## HOPE BAY PROJECT

### **Proponent's Response to Information**

### Requests on Water Licence Applications

February 2018

Figure: **7**

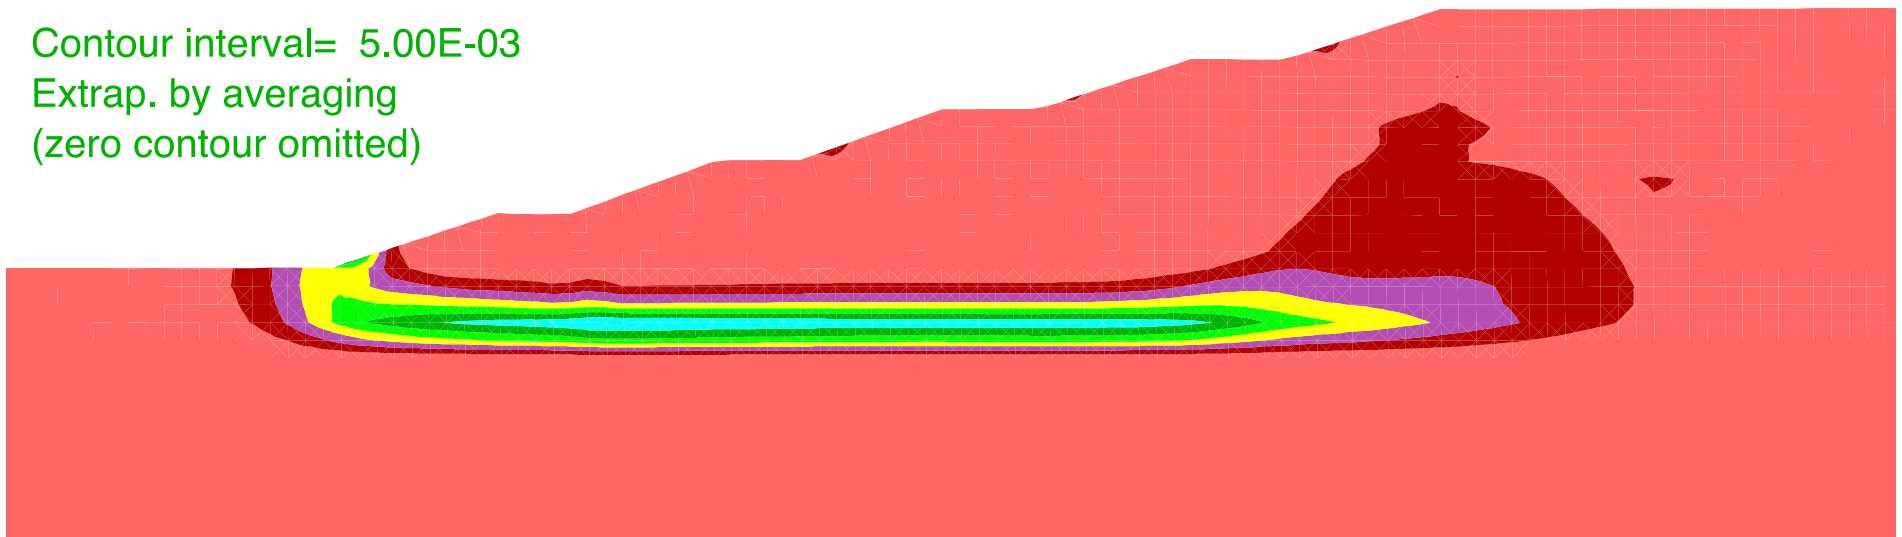
Please comment on the potential impact to closure cover performance from long-term creep deformations noted in referenced project documentation.

The maximum predicted shear strain is around of  $3.3\text{E-}02$  m/m (3.3%) 80 years after dry-stack construction (Figure 7). The maximum shear strain rate is  $3.0\text{E-}08$  year<sup>-1</sup> for the same period (Figures 8). Maximum shear strain and shear strains rates are predicted to occur in points within the shear localization zone (i.e., inside the frozen foundation). Histories of the shear strains and shear strain rates for two selected control points of the FDM (Figure 6) are presented in Figures 9 and 10, respectively.

Figure: **1**

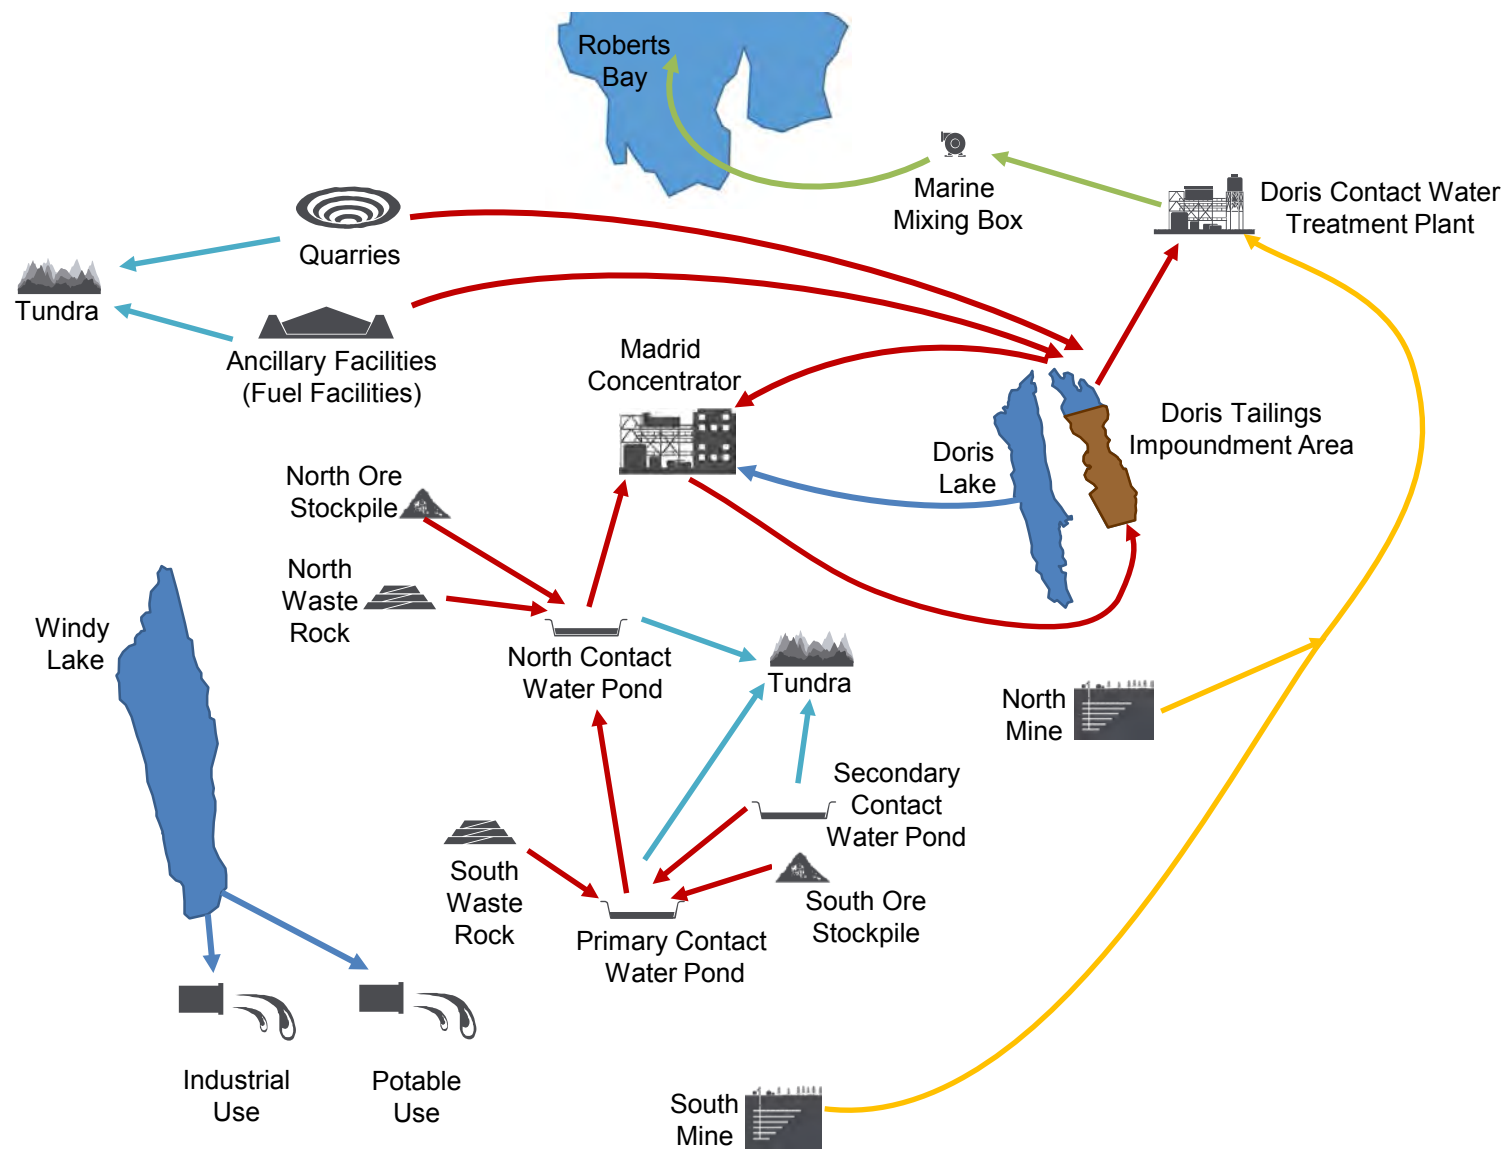
The sections describing monitoring of the Contact Water Ponds suggest that discharge of excess contact water to tundra is contemplated, as an alternative to dewatering to the TIA. However, Figure 1 does not illustrate whether that discharge would be directly from the contact water ponds, or how that effluent would be managed and monitored. Suggest providing more clarity about how contact water would be managed and monitored prior to discharge to tundra. Recommend illustrating the potential discharge of contact water to tundra on Figure 1.

Recommend providing more clarity about how contact water would be managed and monitored prior to discharge to tundra. Recommend illustrating the potential discharge of contact water to tundra on Figure 1.

TMAC acknowledges that the previous Figure 1 does not show the potential discharge from the contact water ponds to the tundra. An updated Figure 1 and Figure 2 is provided as an attachment to this document.

Contact water within the Contact Water Ponds at Madrid will be managed and monitored prior to discharge to tundra, in the same manner as for all other contact water ponds and consistent with existing practices at the Doris mine.

Closure and Reclamation Plan		
		<b>Water Management Schematic-Boston</b>		
Job No: 1CT022.013 Filename: HopeBay_WaterMgmtSchematics_20171121_1CT022-012_sab_ajb_CH_sst.pptx	HOPE BAY PROJECT	Date: Feb. 2018	Approved: SAB	Figure: <b>1</b>

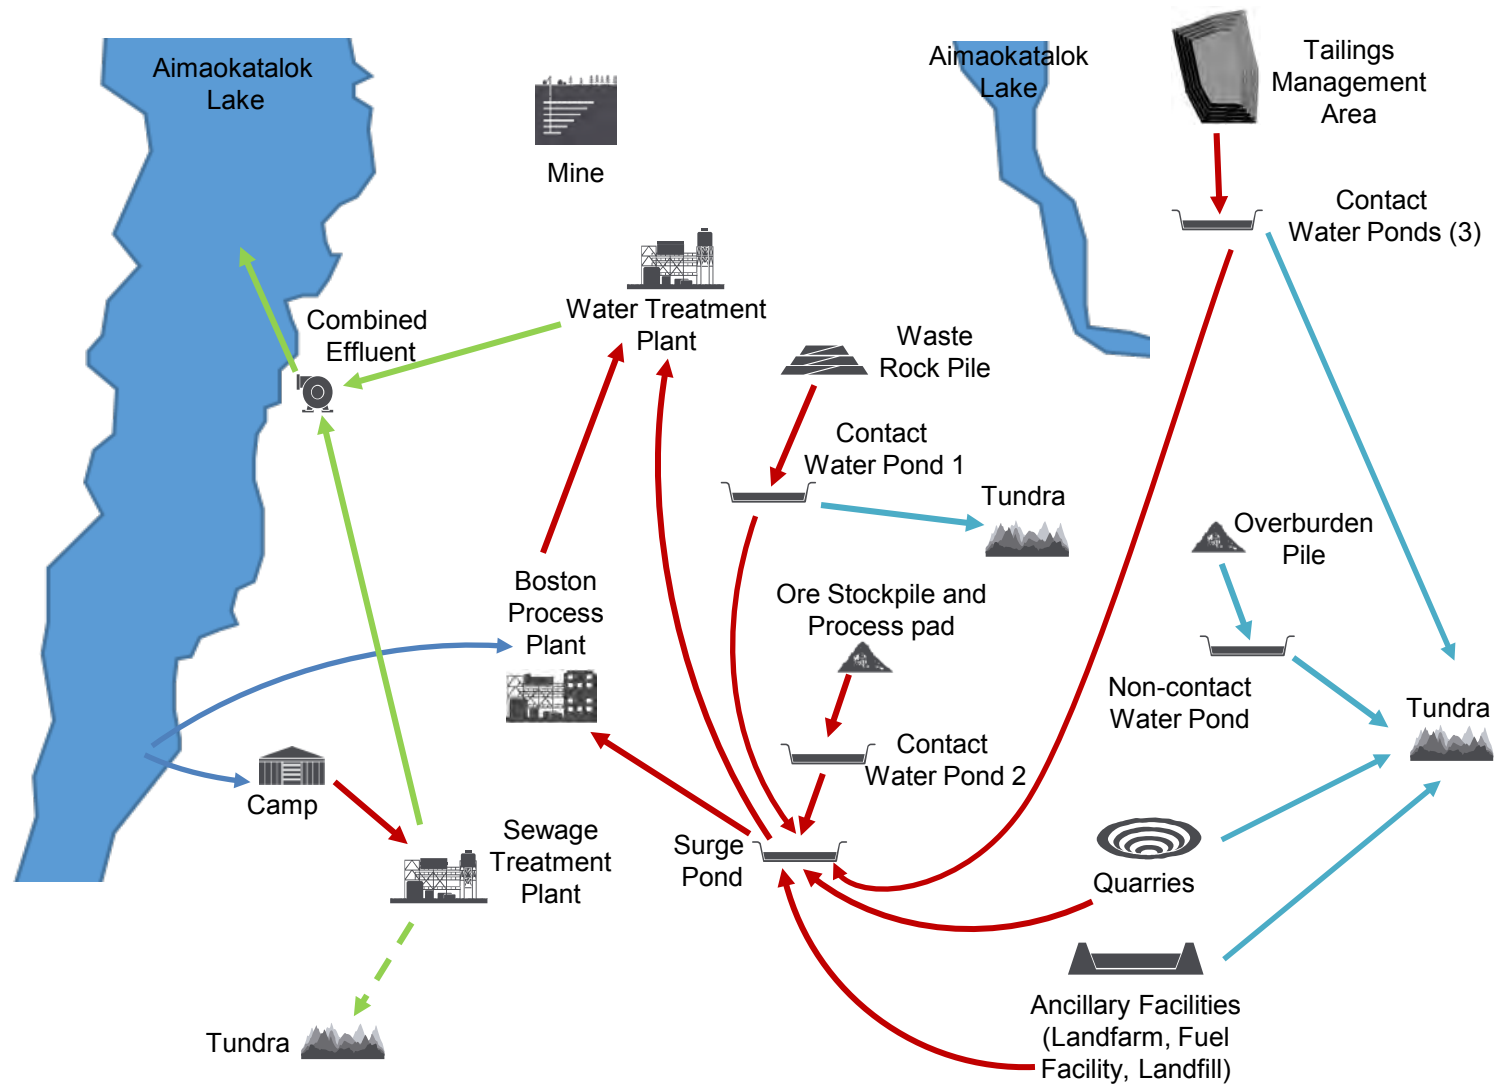
The sections describing monitoring of Contact Water Pond #1 and the TMA Contact Water Ponds suggest that discharge of contact water to tundra is contemplated, if discharge criteria are met. However, Figure 1 does not illustrate whether that discharge would be directly from the contact water ponds, or how that effluent would be managed and monitored. We suggest providing more clarity about how contact water would be managed and monitored prior to discharge to tundra.

- We recommend providing more clarity about how contact water from Contact Water Pond #1 and the TMA Contact Water Ponds would be managed and monitored prior to discharge to tundra.

TMAC acknowledges that the previous Figure 1 does not show the potential discharge from the contact water ponds to the tundra. An updated Figure 1 is provided as an attachment to this document.

As stated in Supporting Document P4-8(Hope Bay Project - Boston Water Management Plan), Sections 3.2.2, 3.4.2 and 3.5.2: "A water quality sample will be collected prior to discharge. If water quality meets the designed criteria for discharge, excess water may be discharged to tundra at an approved location."

**Figure 6-4: Annual Average Wolverine Lake Elevation Probabilities**

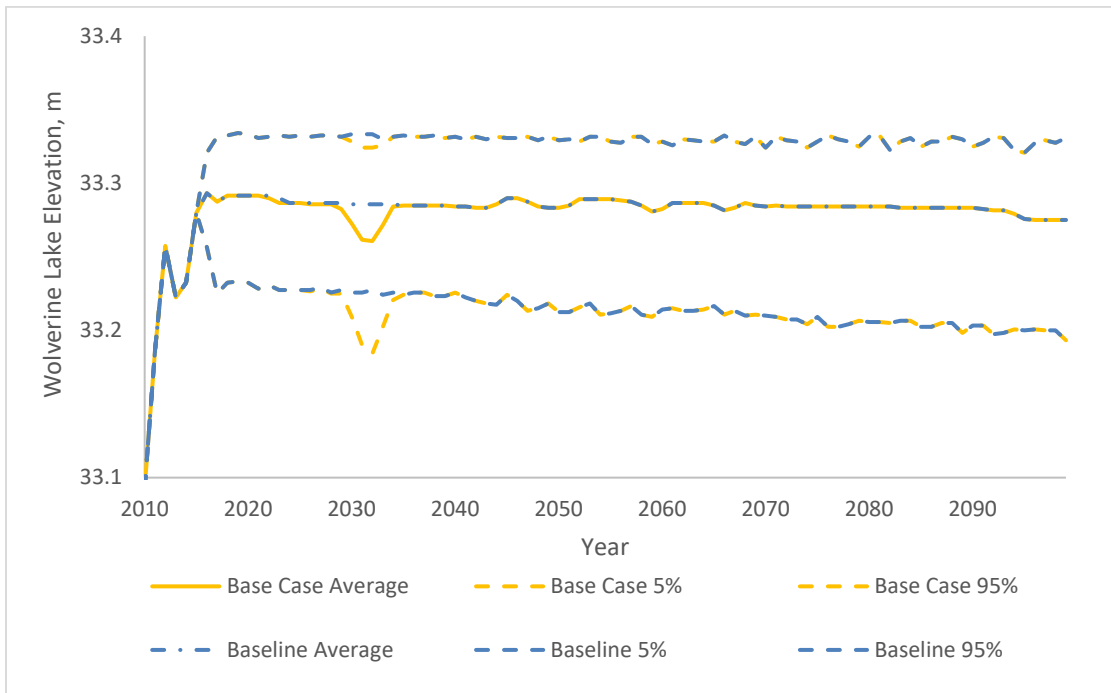
Please add baseline lake elevation lines in the plots showing the lake elevations predicted in the water balance model.

- Figure 6-4 - Wolverine Lake,
- Figure 6-7 - Imniagut Lake,
- Figure 6-11 - Patch Lake,
- Figure 6-17 - Doris Lake,

Baseline lake elevations at assessment nodes under the average, 1-in-20-year dry, and 1-in-20-year wet conditions are presented in Appendix V5-1N of the FEIS.
